24

Fig. 24

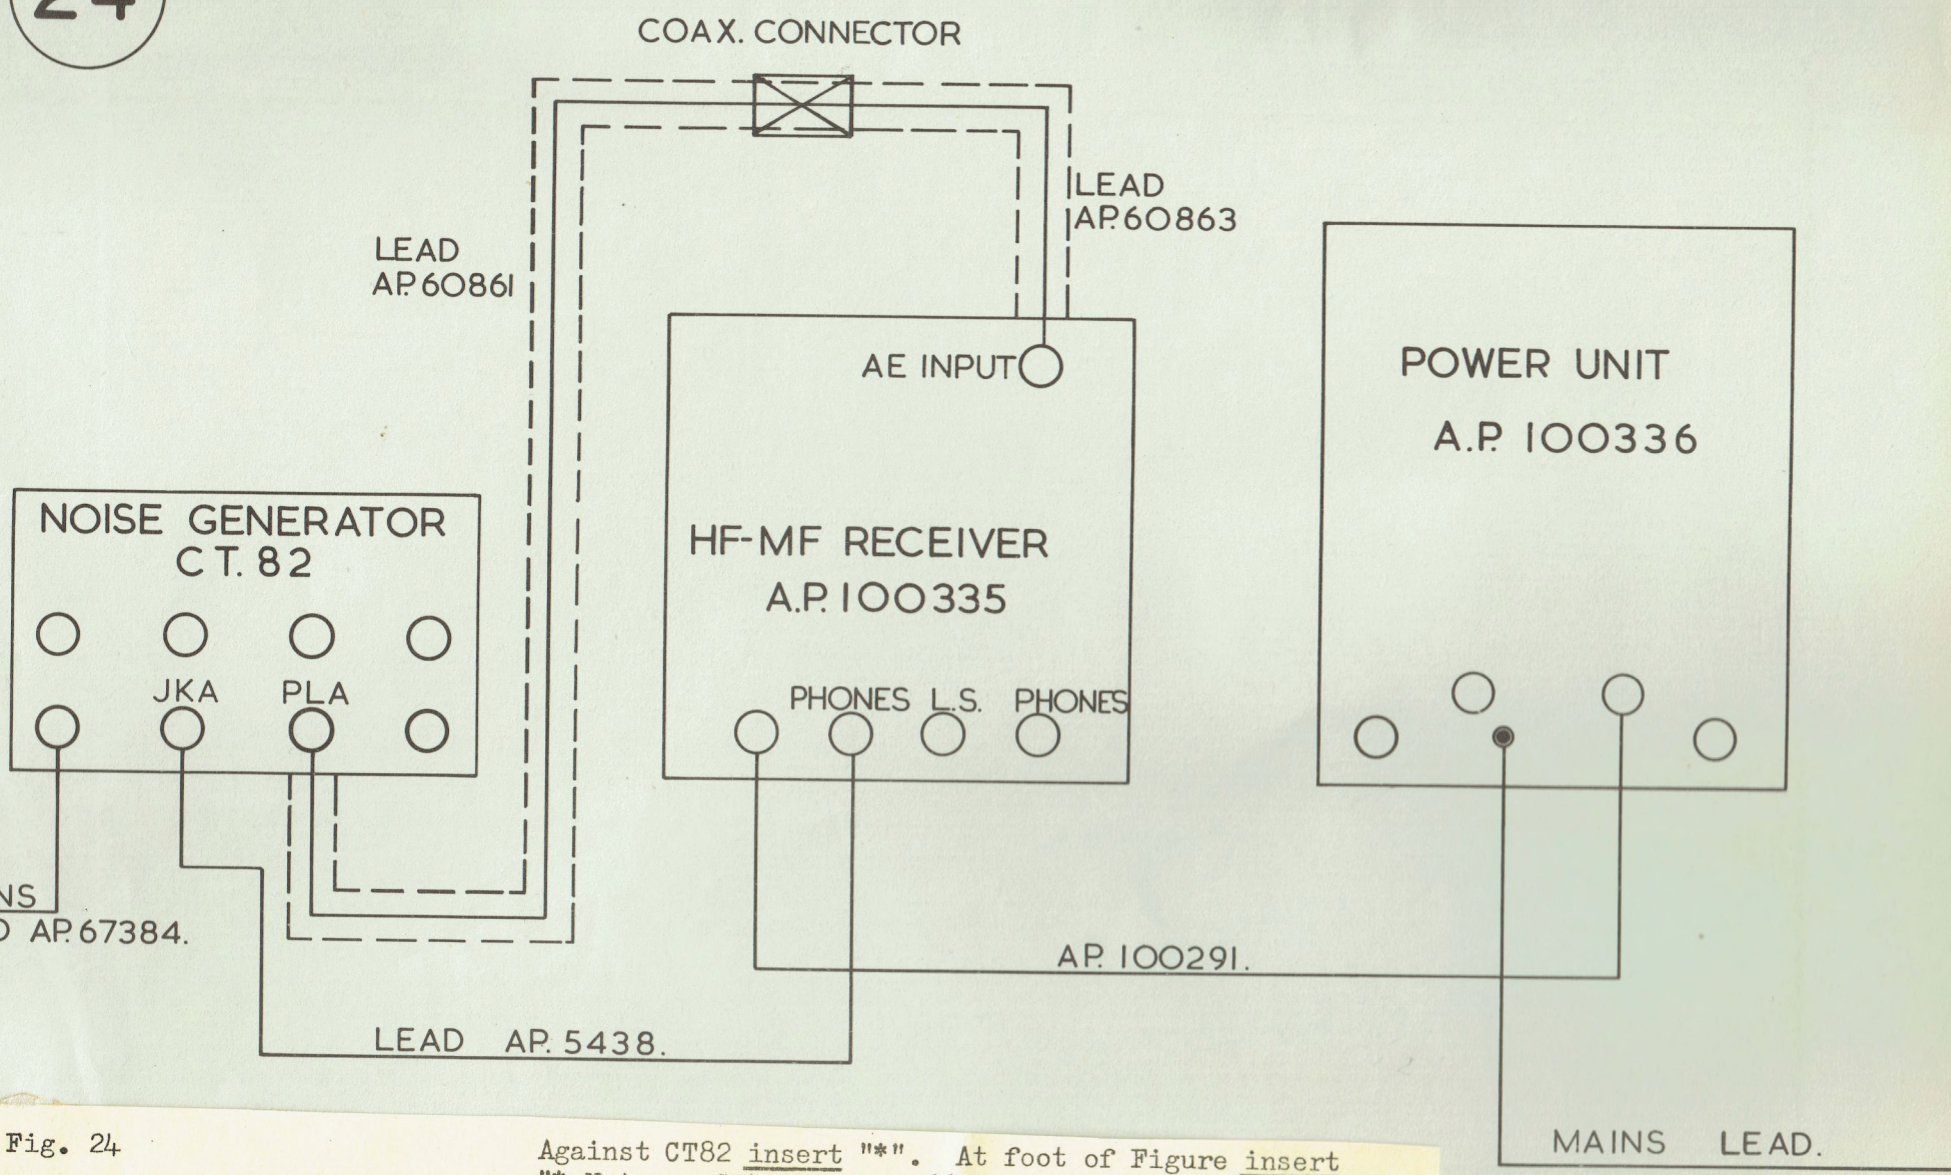
Against CT82 insert "***". At foot of Figure insert
** Note:- CT410 N.S.N. 6625-99-580-1668 may also
be used, set INPUT IMPEDANCE to 600 ohm, connect
AUDIO INPUT to receiver L.S. socket for all tests
and read Noise Factor on 75 ohm scale. See
B.R.1771(43)
